INSTRUCTIONAL BULLETIN NO. 15-13

Regarding Revised Standard Drawings

Effective Apr. 1, 2016 letting (Jan. 20, 2016 Turn-in), the following Standard Drawings have been revised. Section V of the Design Guidelines is revised to incorporate these changes.

T-S-12

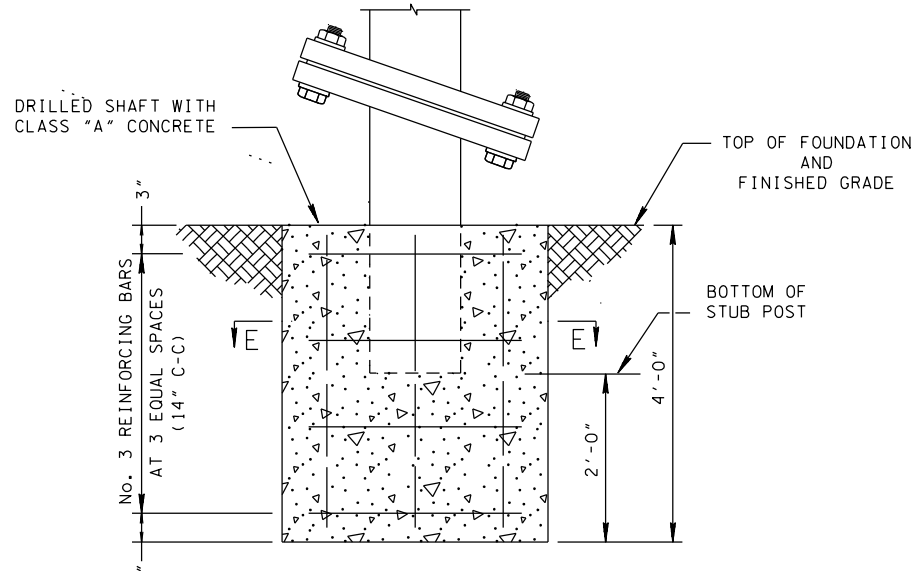
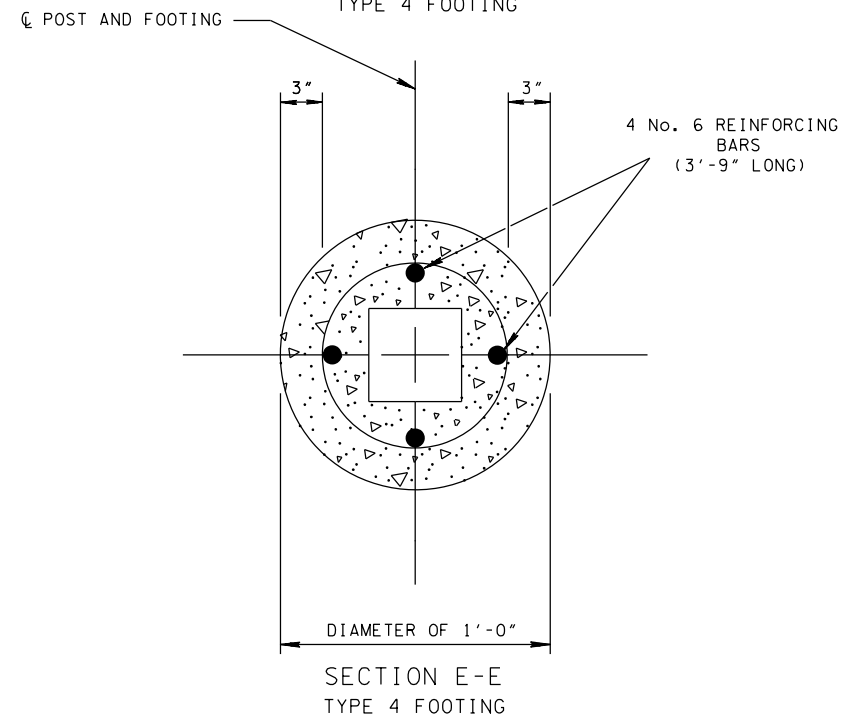
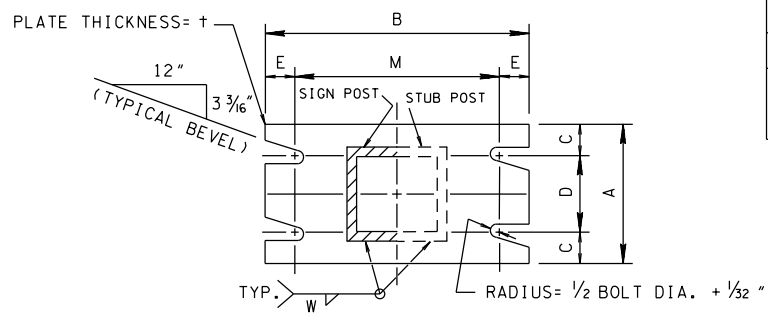
- REV. 10-26-96: CHANGED PAY ITEM NO. IN GENERAL NOTE (M).
- REV. 5-27-01: CHANGED NOTE UNDER SHIM DETAIL.
- REV. 5-27-03: CORRECTED GENERAL NOTE (E).
- REV. 7-2-15: REVISED TUBE SIZE. ADDED GENERAL NOTE (P).

T-S-16

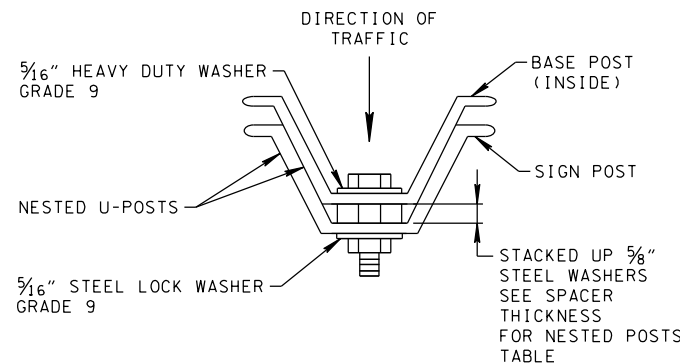
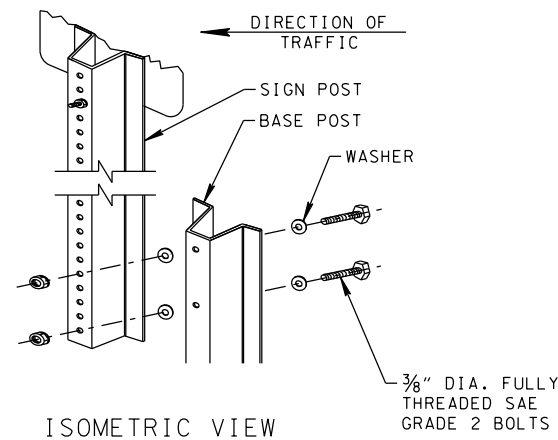
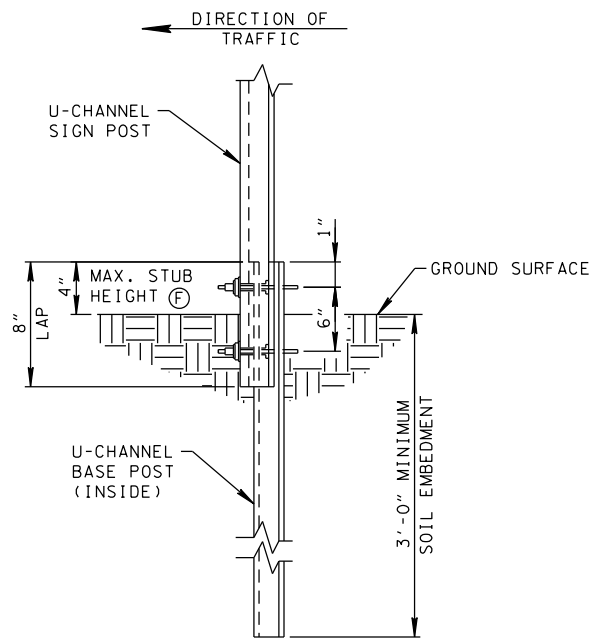
- REV. 11-1-11: REVISED GENERAL NOTES (A) AND (D). ADDED GENERAL NOTE (E). CHANGED R-15-2 SIGNS TO R15-2P.
- REV. 6-5-14: COMBINED T-S-16 AND T-S-16A.
- REV. 7-2-15: ADDED SINGLE DIRECTIONAL BREAKAWAY LAP SPLICE. ADDED FOOTNOTES (E).

T-S-16A

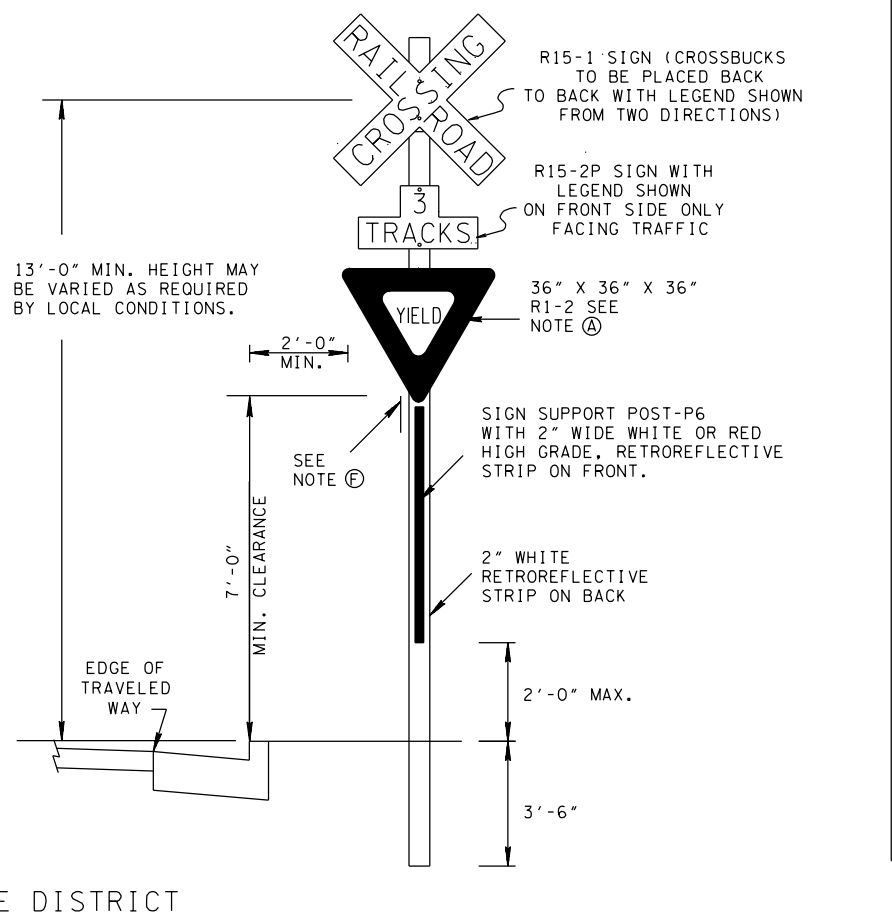
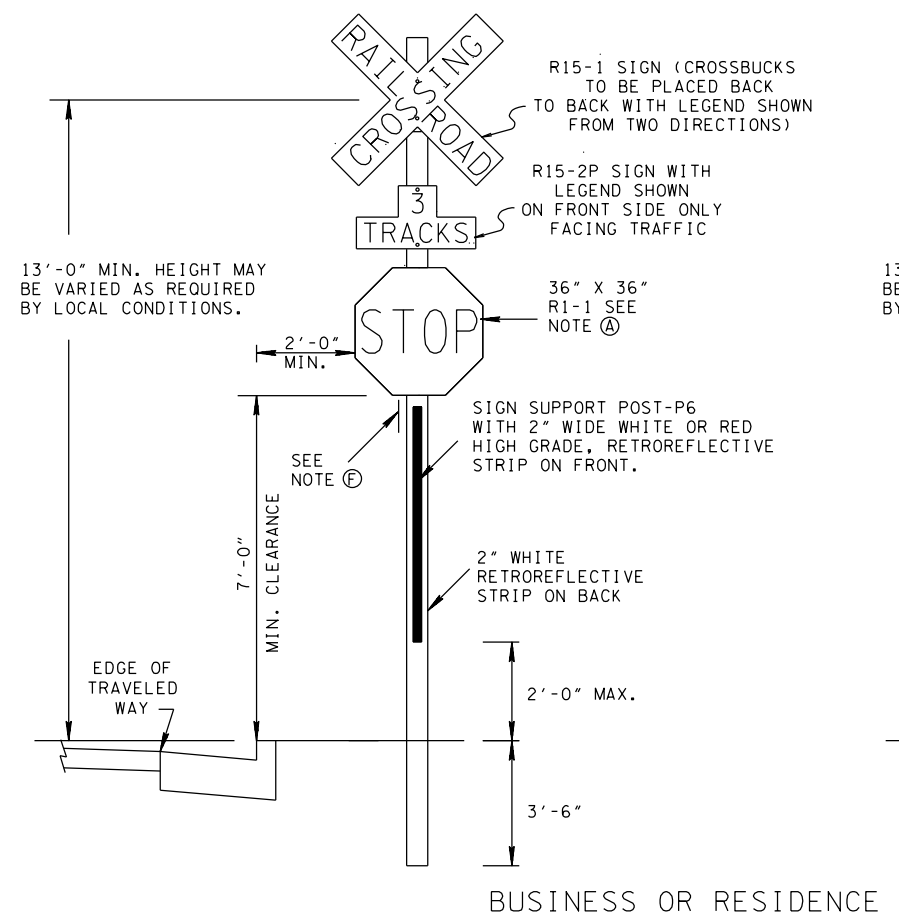
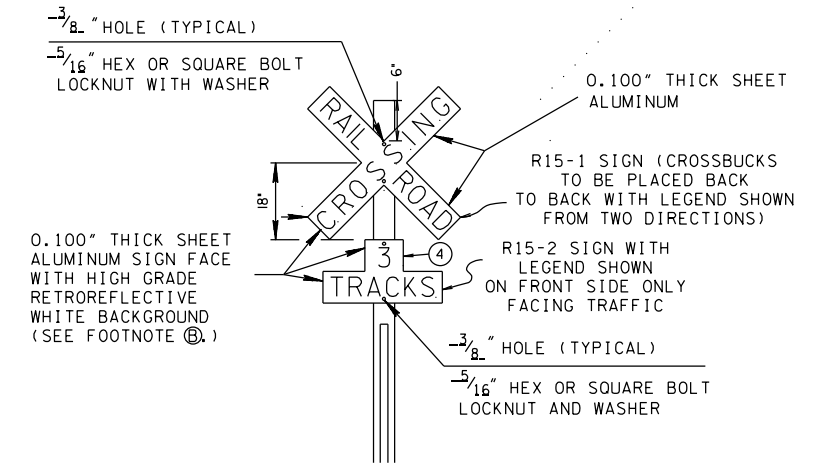
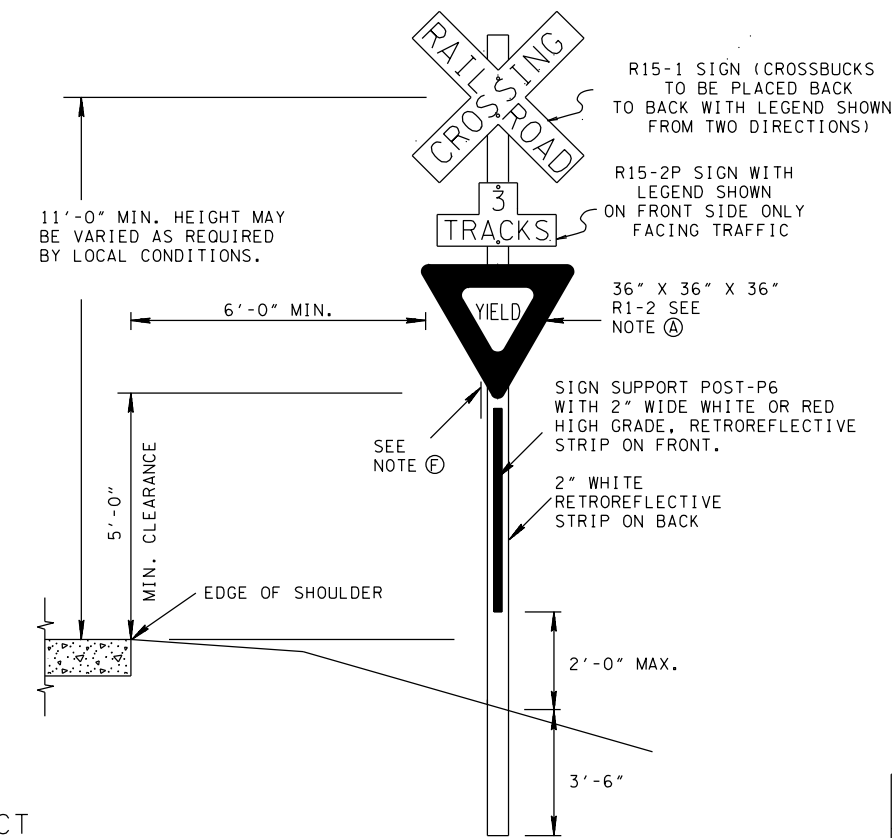
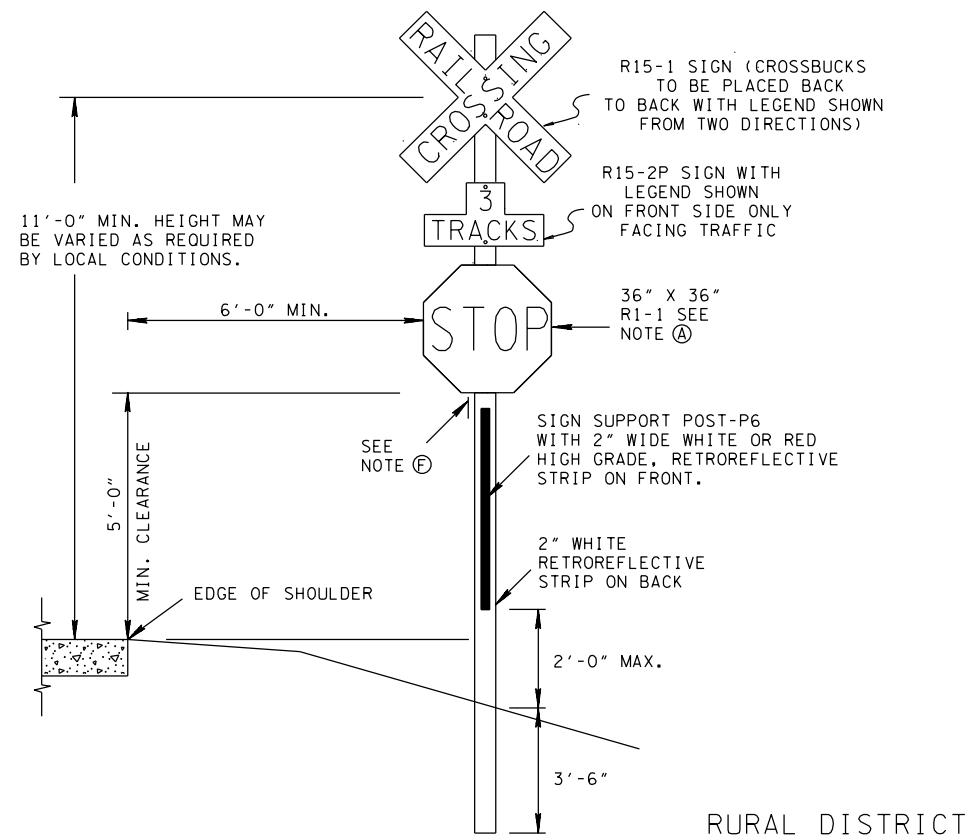
REV. 7-2-15: ADDED DETAILS. ADDED GENERAL NOTES (H).

SHOULDER INSTALLATION FOR ONE PERFORATED/KNOCKOUT SQUARE TUBE SUPPORT

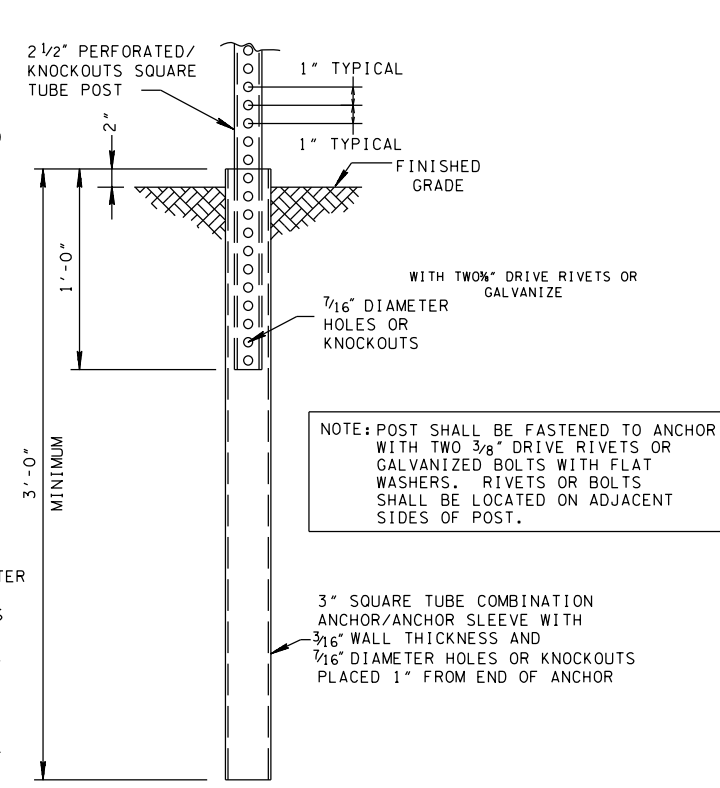
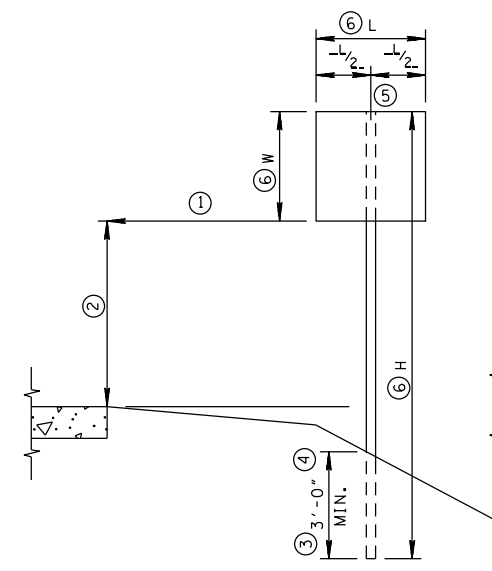
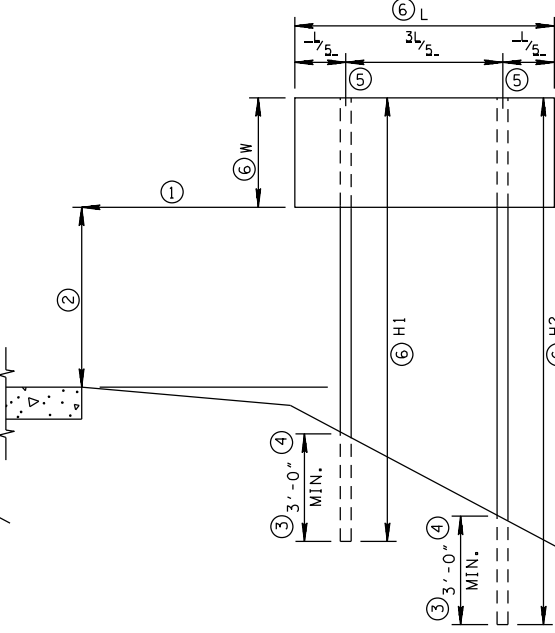
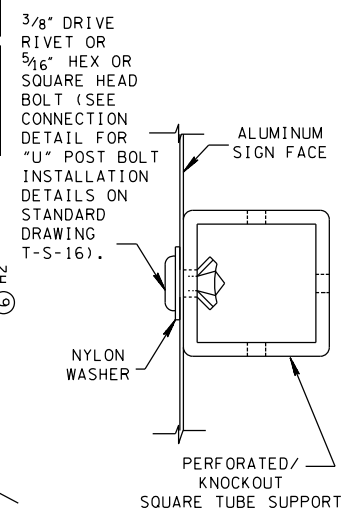
- REV. 7-2-15: REVISED FOOTNOTES (3) ADDED GENERAL NOTES (L).

09-01-12 T-S-23A

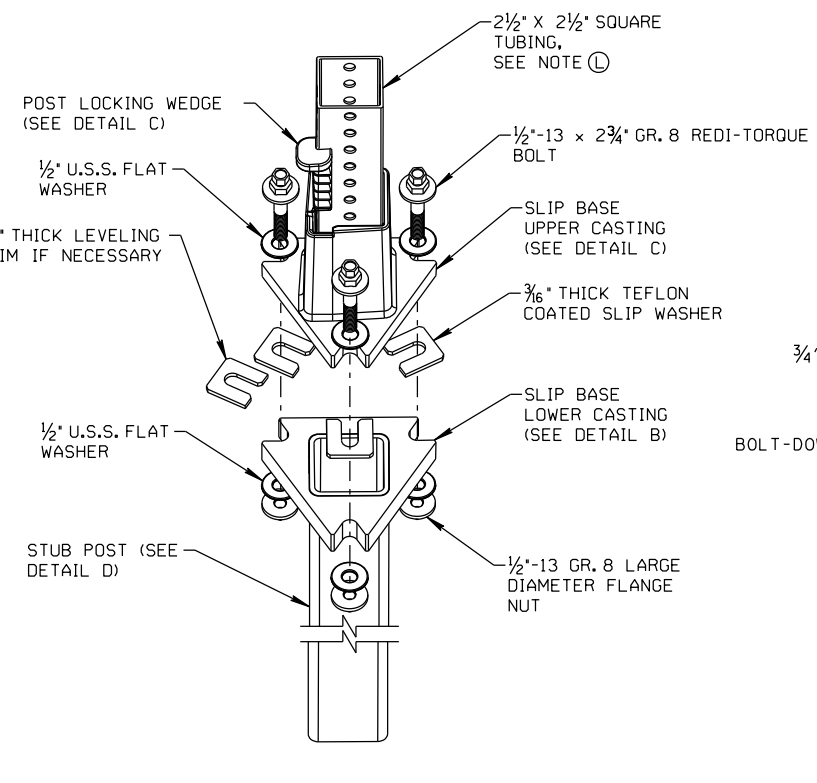
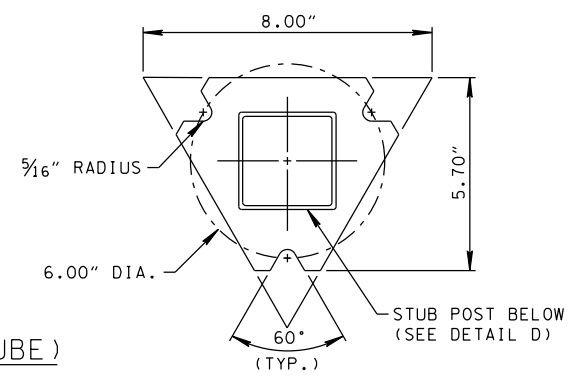
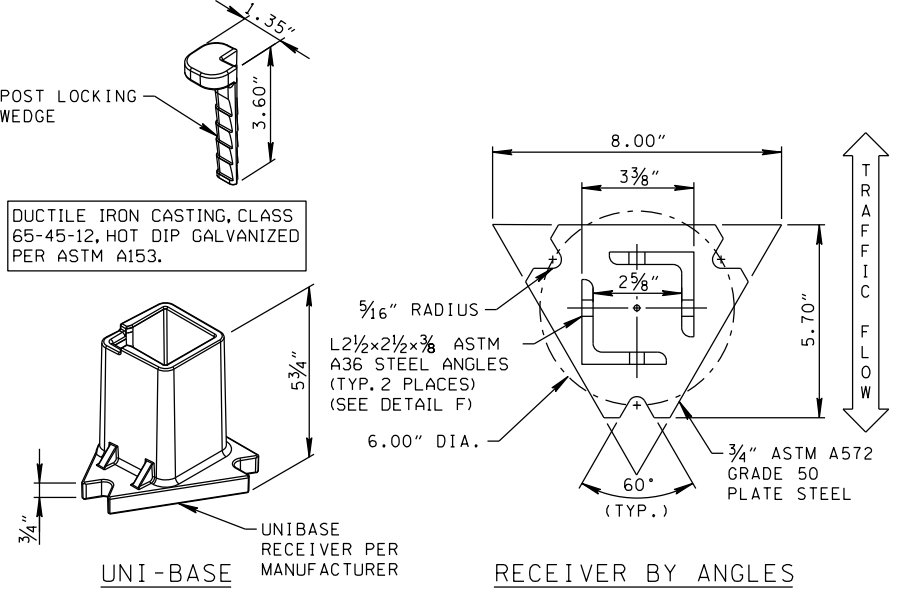
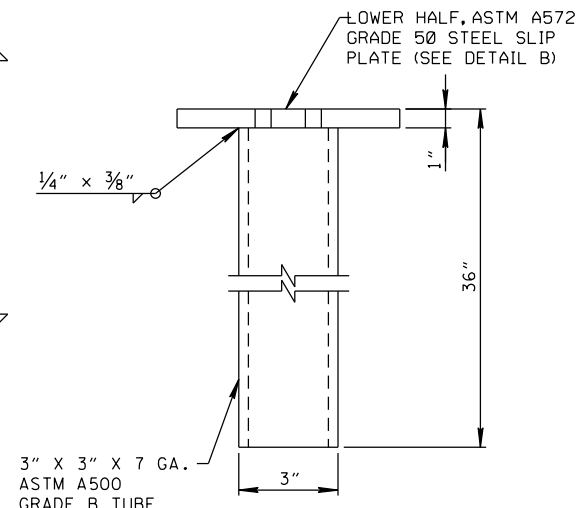
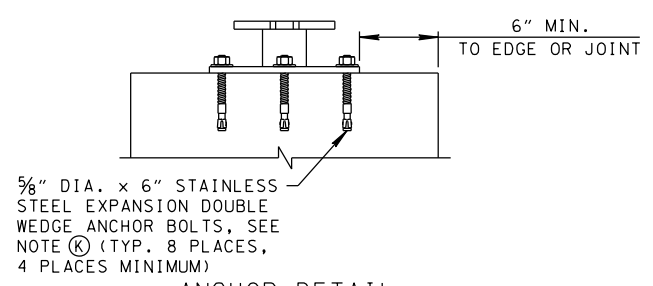
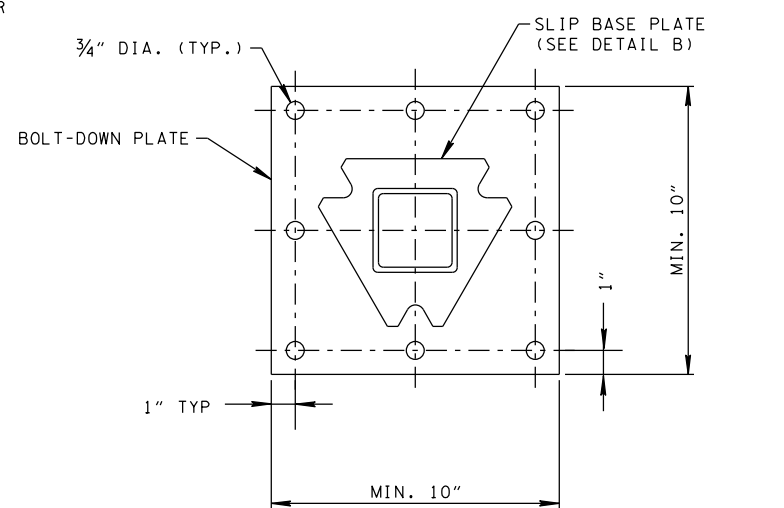
- REV. 7-19-13: ADDED NOTE (N). MINOR EDITS TO DRAWINGS. MODIFIED NOTE (M).
- REV. 8-25-14: REVISED NOTE (H).
- REV. 7-2-15: REVISED GENERAL NOTES AND FOUNDATION DETAILS.
